Town of Hilton Head Island Regular Design Review Board Meeting

Tuesday, March 13, 2012

DESIGN TEAM/DRB COMMENT SHEET

PROJECT NAME: HH Christian Academy Practice Gym/ Classroom

NORTH ELEVATION

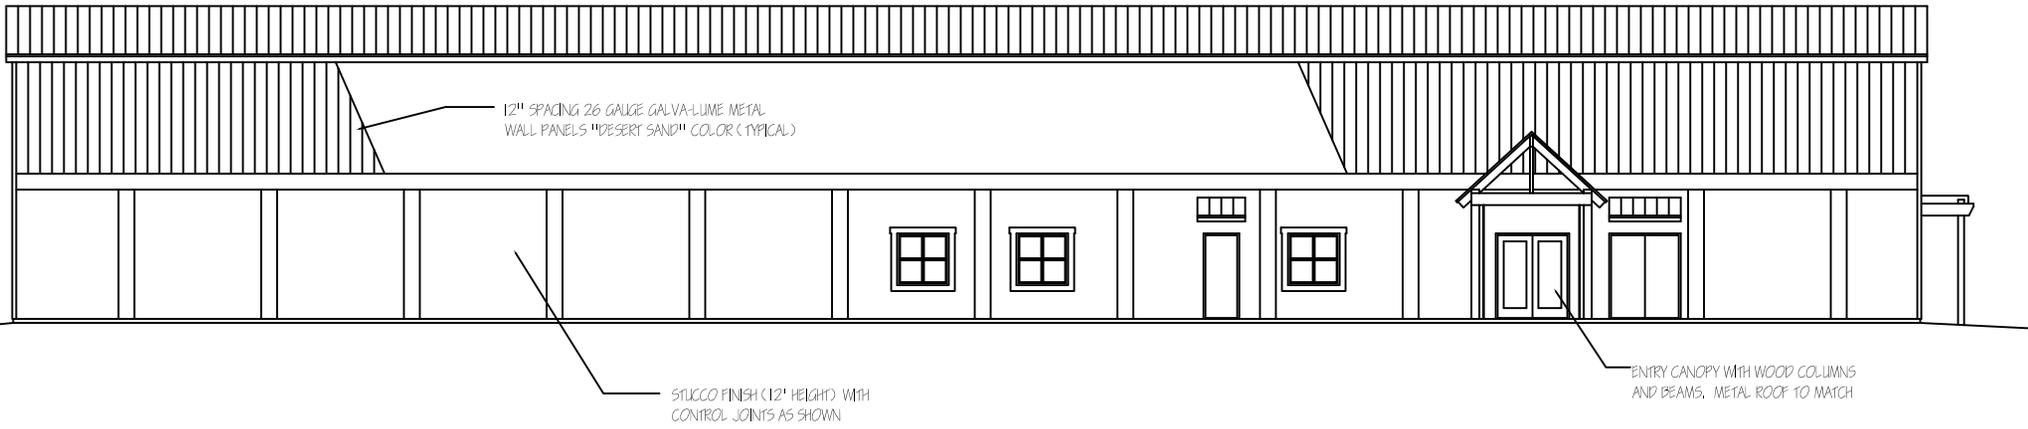
The landscape on the north elevation should correspond to the architectural elements on that side of the building (i.e. the trees will be growing into the trellises upon installation).

SOUTH ELEVATION

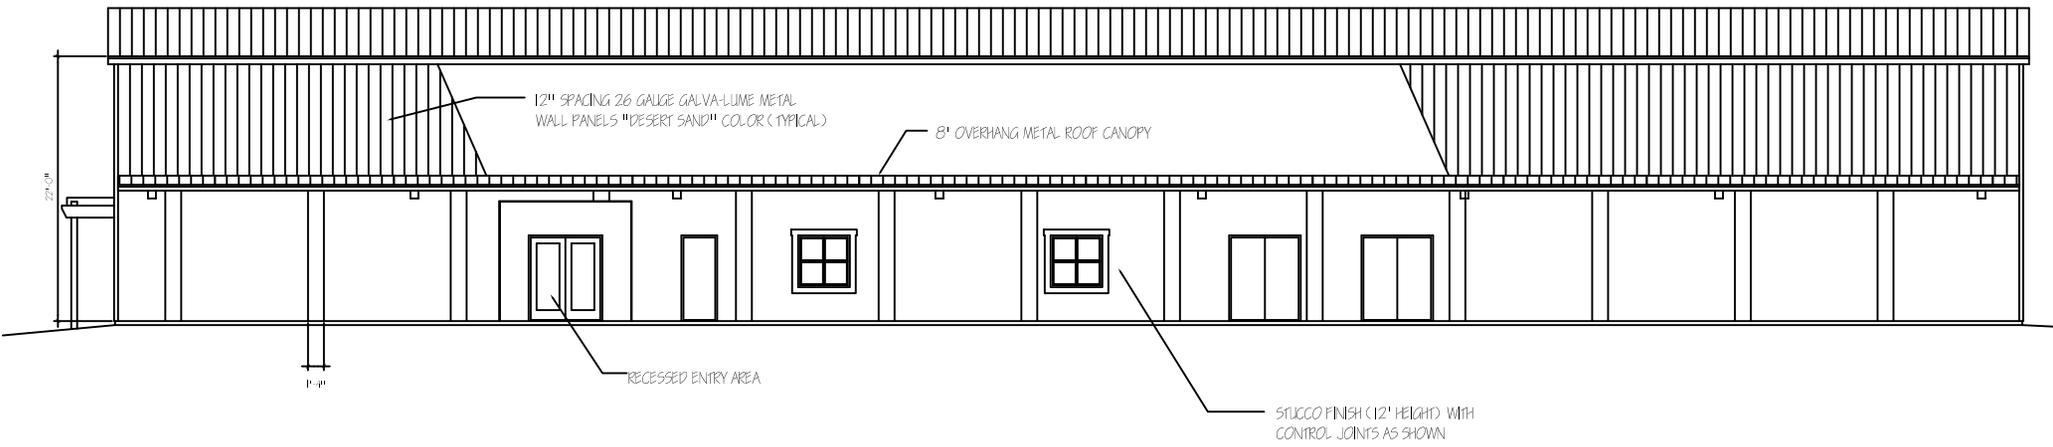
All facades are have equal design characteristics	<input checked="" type="checkbox"/>	<input type="checkbox"/>	<input type="checkbox"/>	South is still sparsely composed, but fits program of interior
Avoids monotonous planes or unrelieved repetition	<input checked="" type="checkbox"/>	<input type="checkbox"/>	<input type="checkbox"/>	Last submission implied pilasters were utilized in the stucco elements, where they are now labeled as control joints. Pilasters might add some shadow to the facades
Has a strong roof form with enough variety to provide	<input type="checkbox"/>	<input checked="" type="checkbox"/>	<input type="checkbox"/>	Overhang now introduced on the 1/12 roof

PARKING LOT ELEVATION 1
SCALE: 1/4"=1'-0" A-2

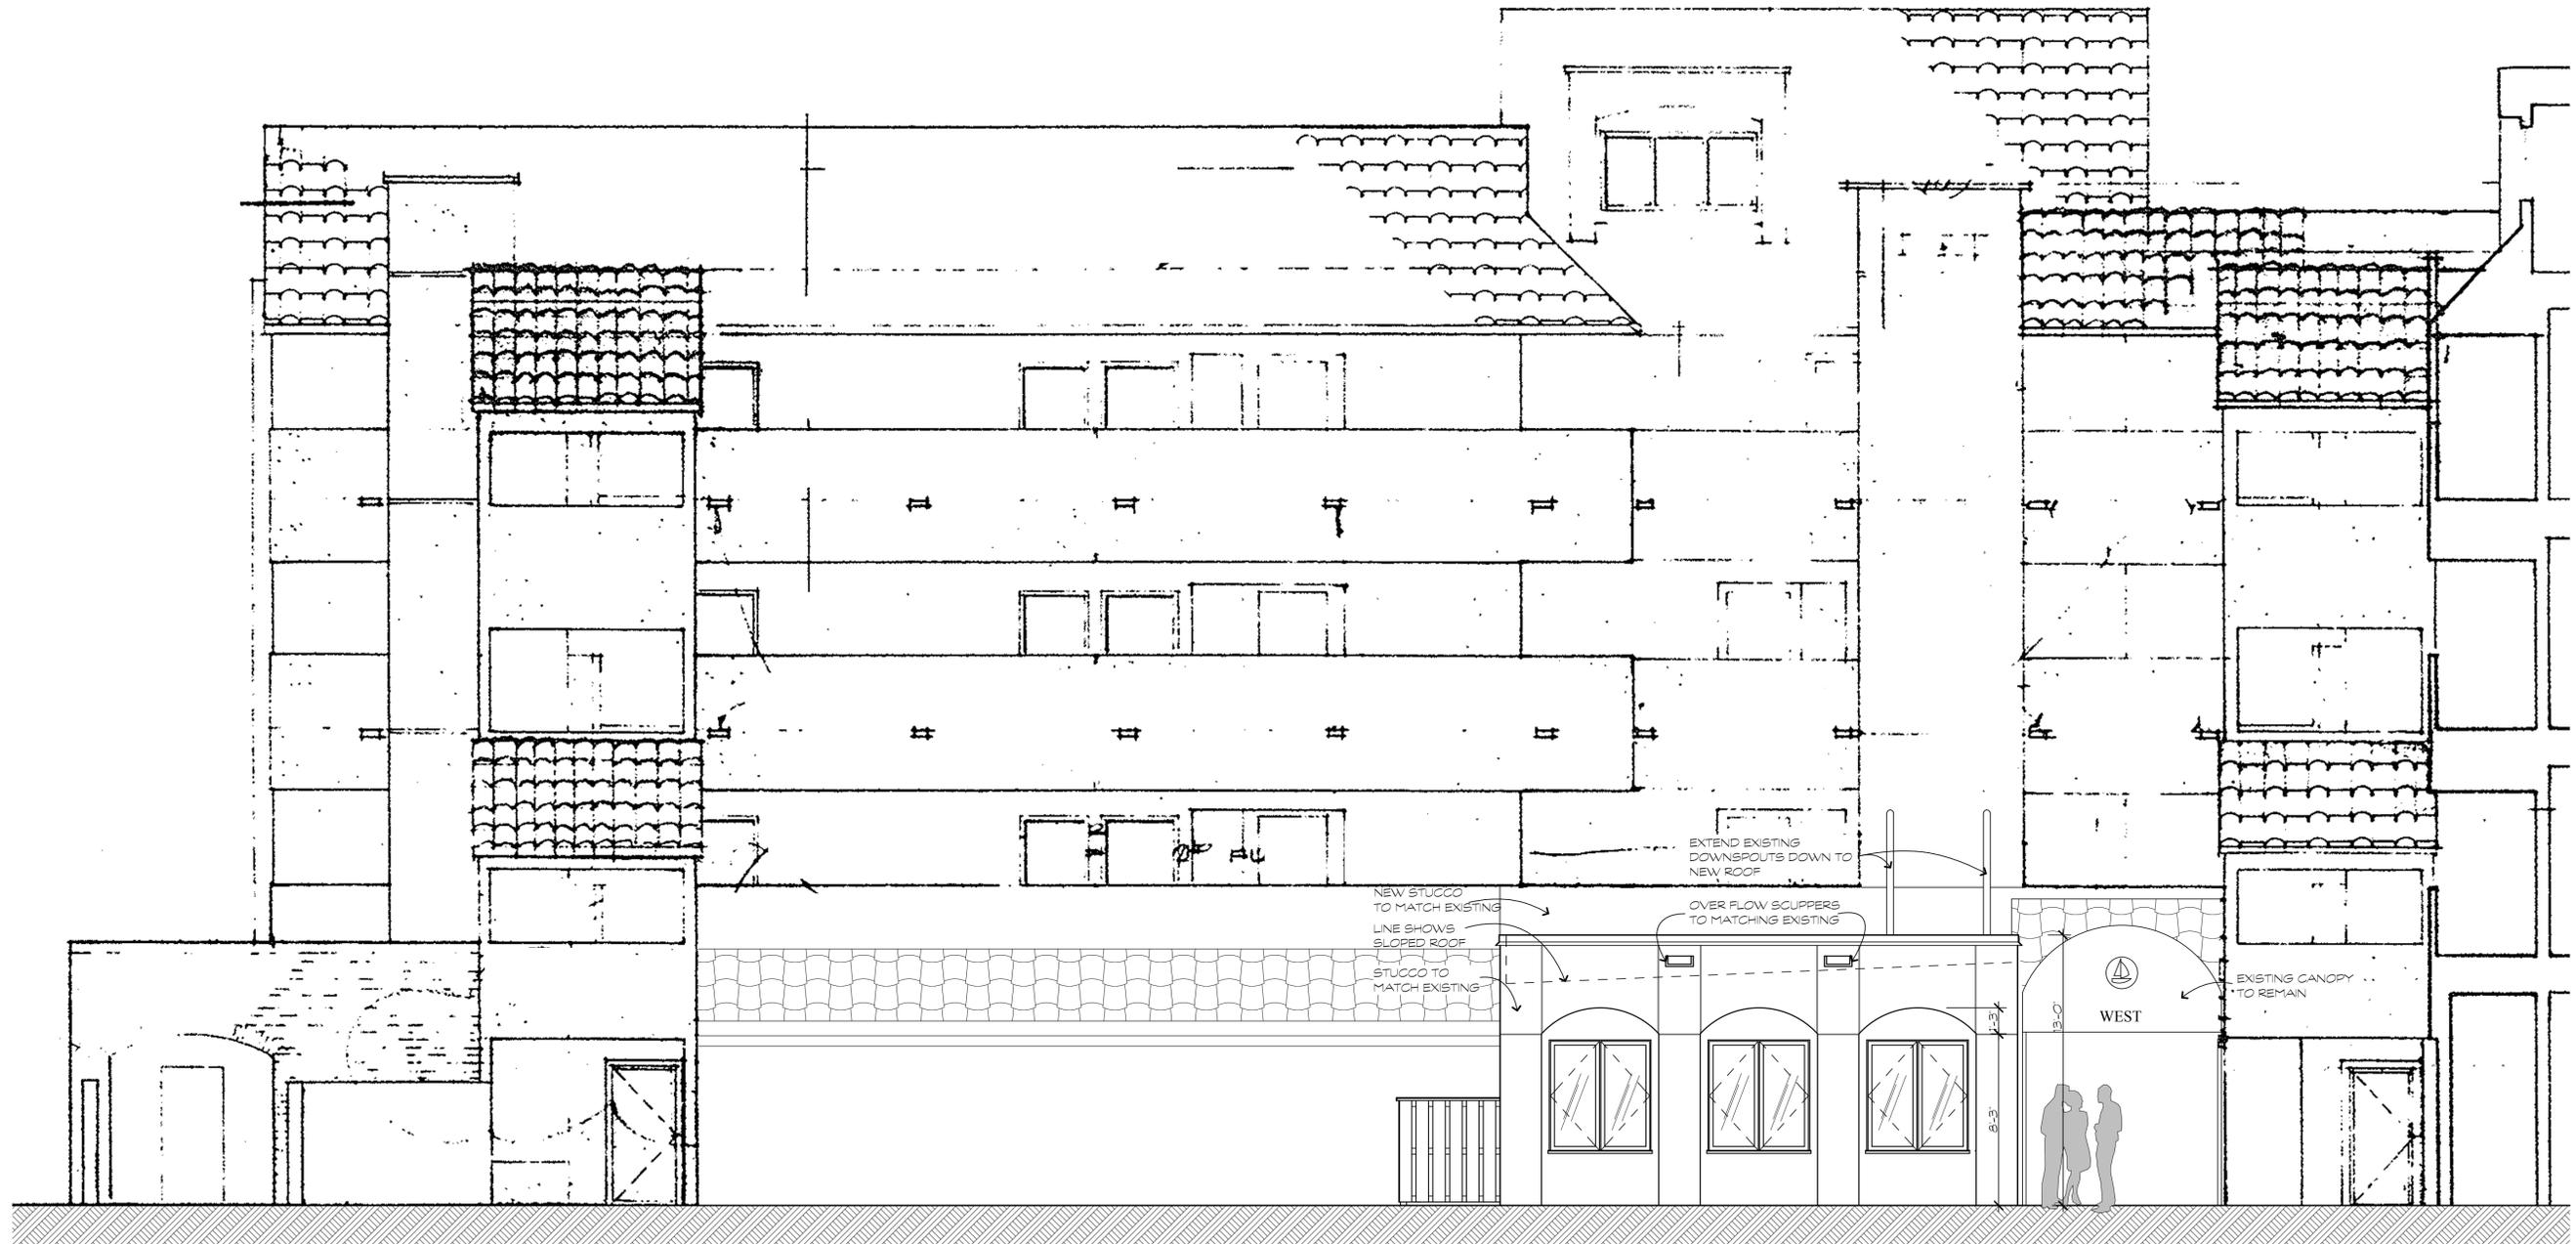
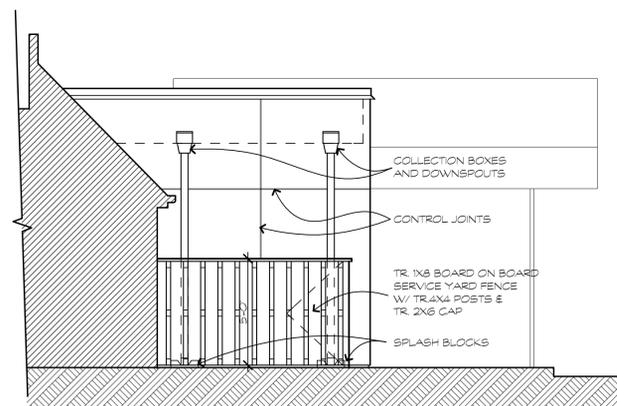
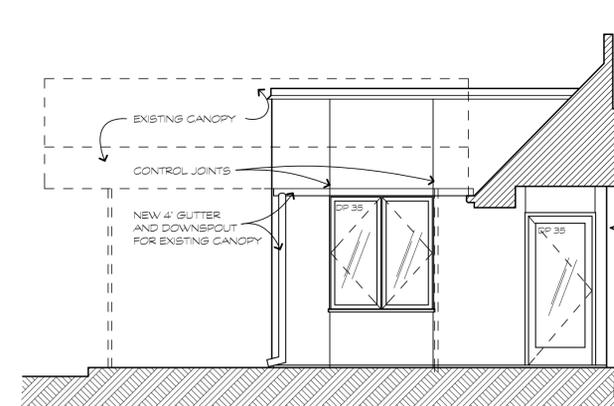
Project adds a 400 SF office to the front of the existing Harbourside building. Materials, finishes, colors, etc. all match existing. Flat roof form strays from the Design Guide, but given the overall mass of the building and the unusual existing roofline at the first floor level, it helps highlight and identify the registration office, and integrates nicely. A landscape plan will need to be submitted for the area between the office and sidewalk and to repair/replace the remaining landscape, post-construction.
